## AMENDMENT 2

- 2 BUNGALOW HOMES ADDED
- N. QUEMOY CT. EXTENDED NORTH
- BUFFER LANDSCAPE ALONG PICADILLY PHASED

GREEN VALLEY RANCH EAST  
PRELIMINARY SITE PLAN #5  
TITLE: KEYMAP  
DATE: March 8, 2023

GREEN VALLEY RANCH EAST  
PRELIMINARY SITE PLAN #5  
TITLE: LANDSCAPE PLAN  
DATE: March 2, 2023

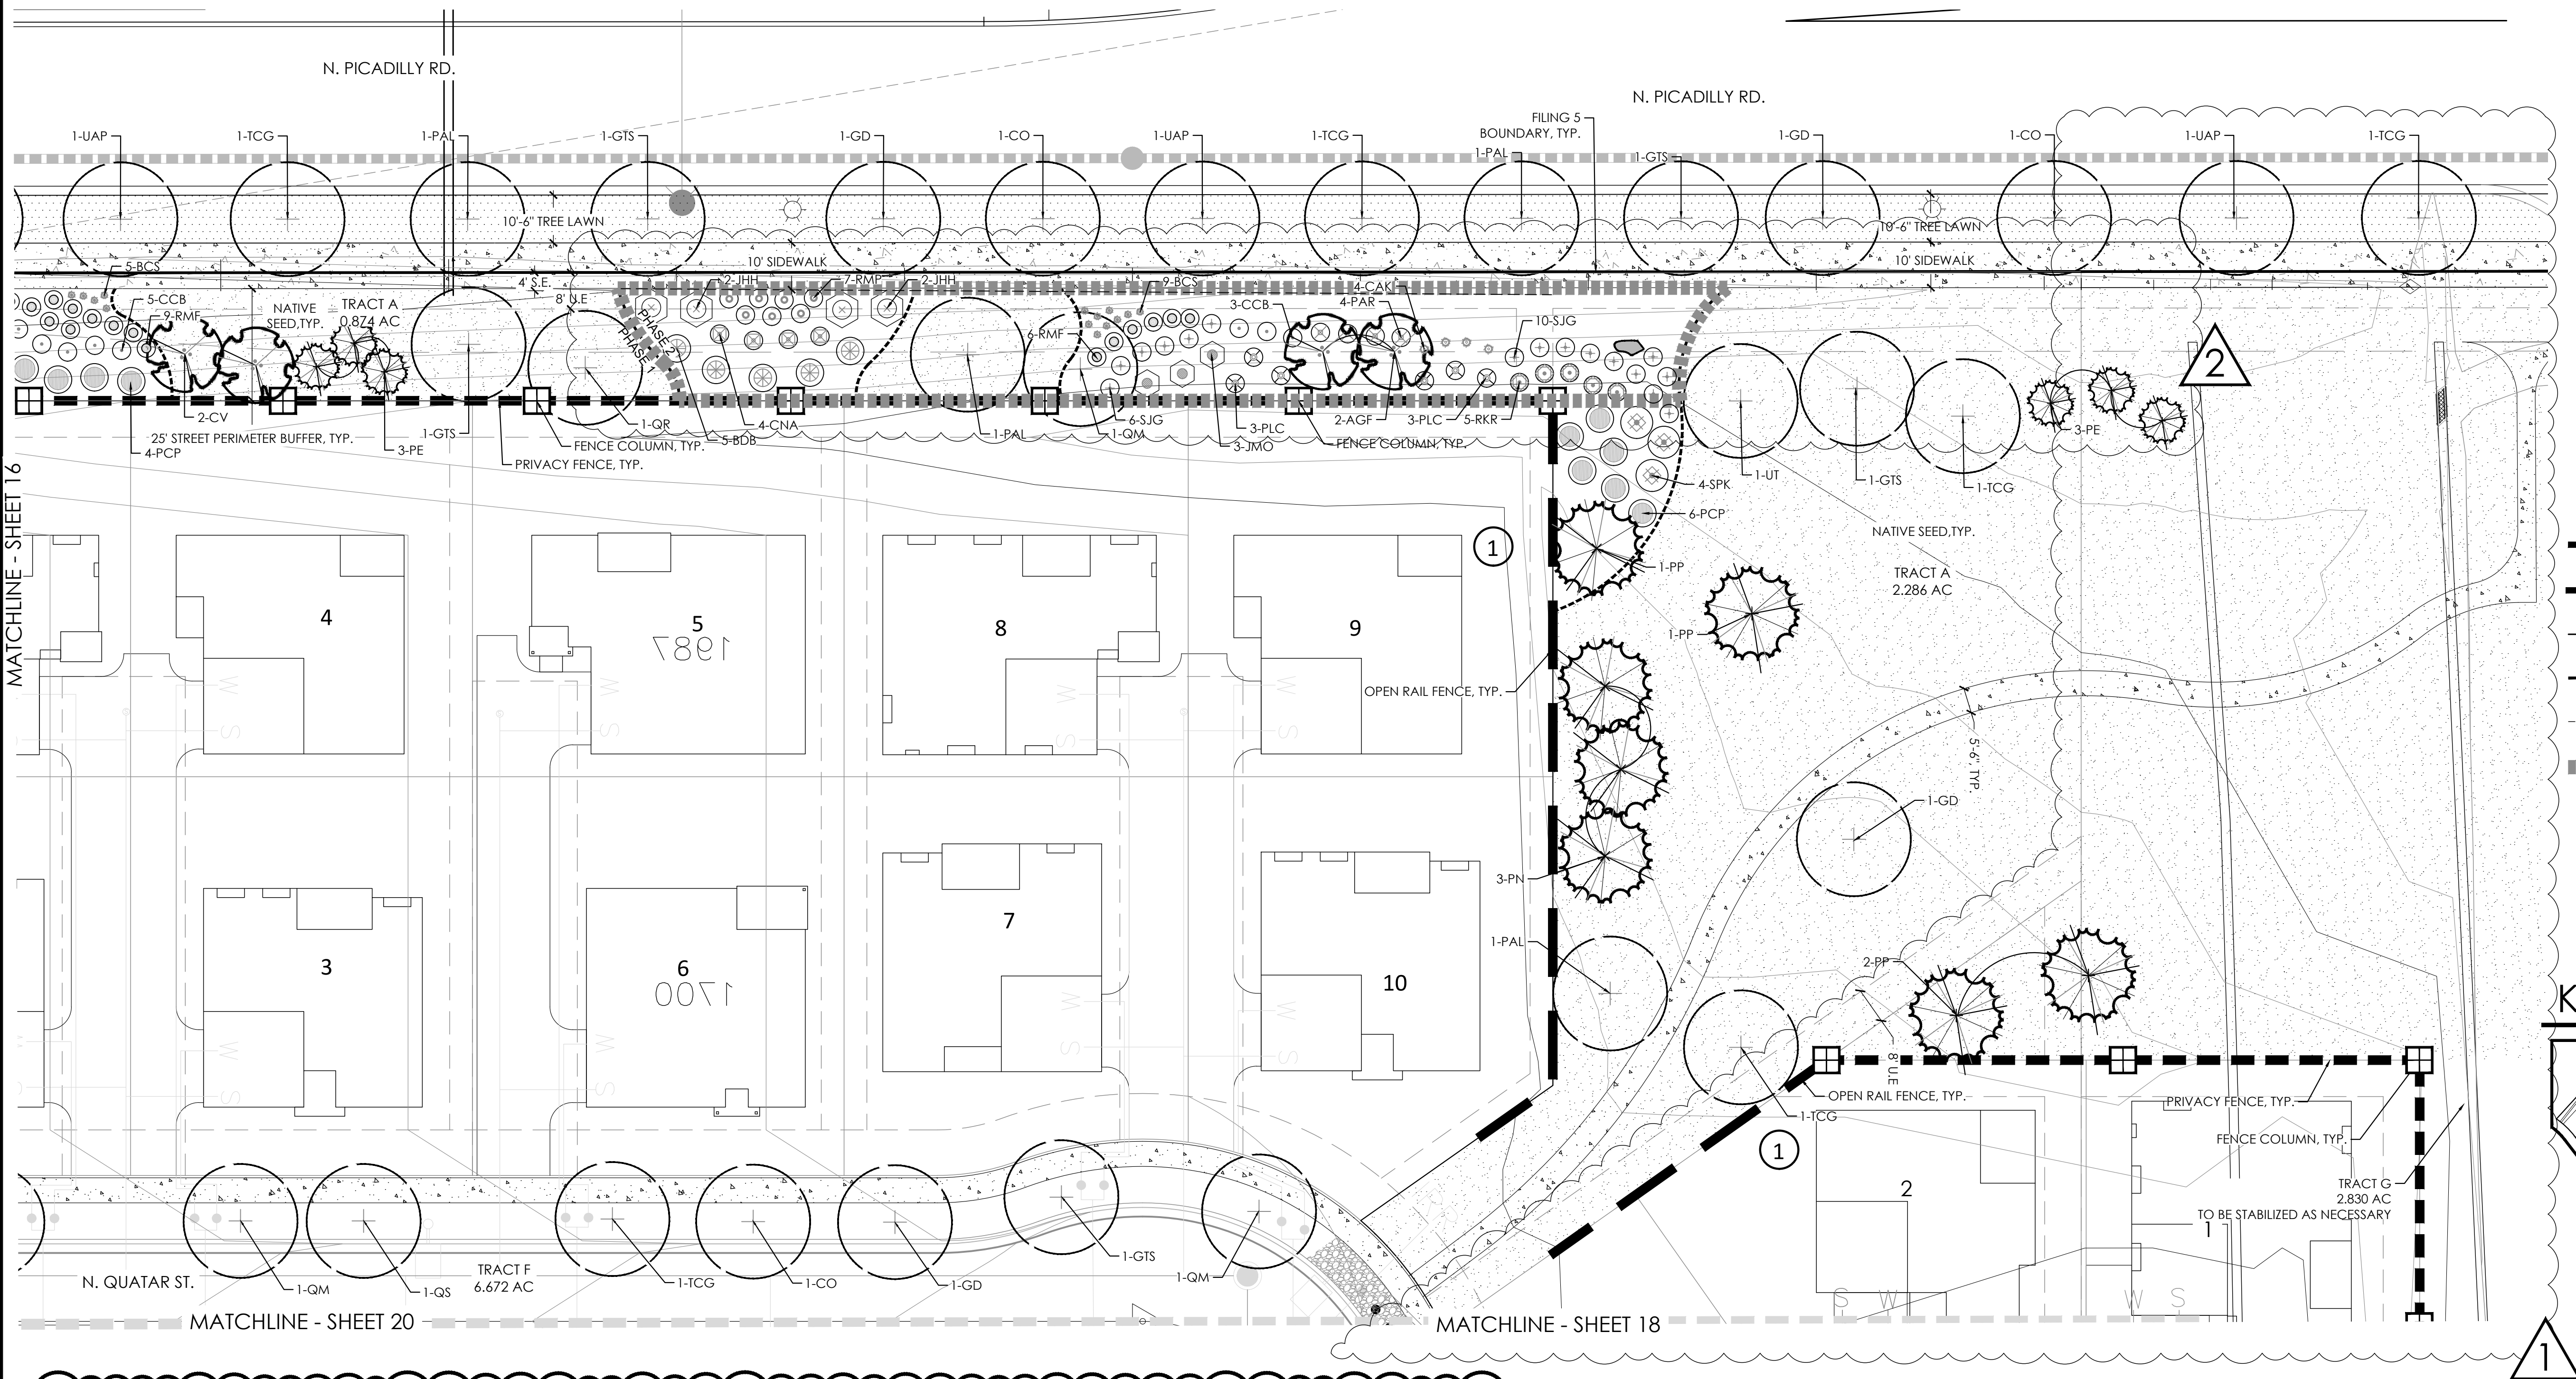
AMENDMENT 1  
- 7 BUNGALOW HOMES ADDED  
- TREES AND NATIVE SEED ADDED

AMENDMENT 2  
- ADDED PHASE LINE  
- ADJUSTED PLANTING  
- BUFFER TABLE ADDED

GREEN VALLEY RANCH EAST  
PRELIMINARY SITE PLAN #5  
TITLE: LANDSCAPE PLAN  
DATE: March 2, 2023

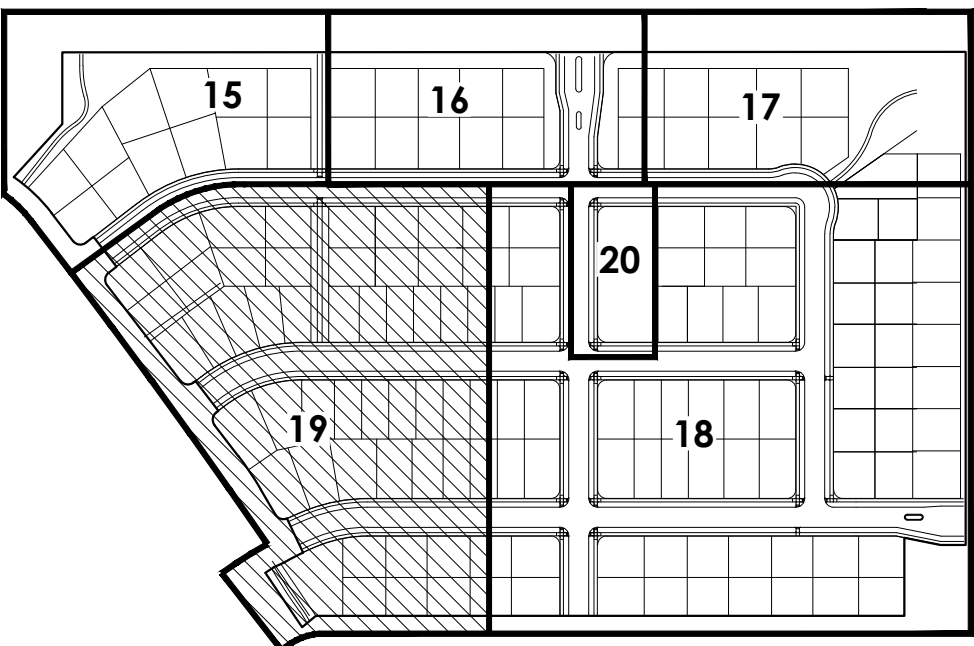
AMENDMENT 3

- SWAPPED SINGLE FAMILY HOMES FOR DUPLEX
- ADJUSTED UTILITY SERVICES
- ADJUSTED STREET TREES
